CITY OF NEWPORT BEACH

RESIDENTIAL FIRE SPRINKLER PLAN CORRECTION LIST

This plan check is according to 2007 California Building Code.

Note: This correction list is applicable to R3 occupancy (one & two dwelling units). (NFPA 13D, 1999 Edition)

SINGLE-FAMILY - SPRINKLER RISER ASSEMBLY

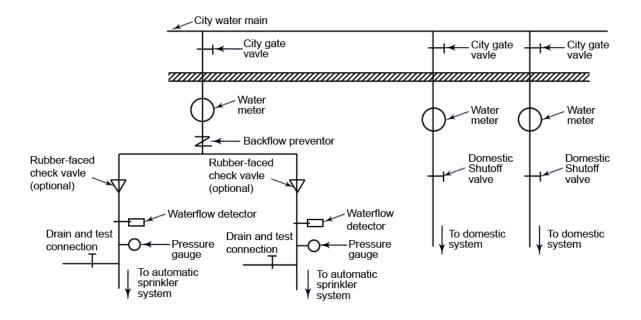
- 5. See riser assembly details below. Riser assembly to include:
 - a. Main control valve, which controls the sprinkler system & domestic water supply.
 - b. Domestic water supply valve, which controls the domestic water supply only.
 - c. Pressure gage
 - d. Check valve
 - e. Water flow switch
 - f. Test/drain valve
 - g. Type of backflow preventer to be approved by the Utilities Department.
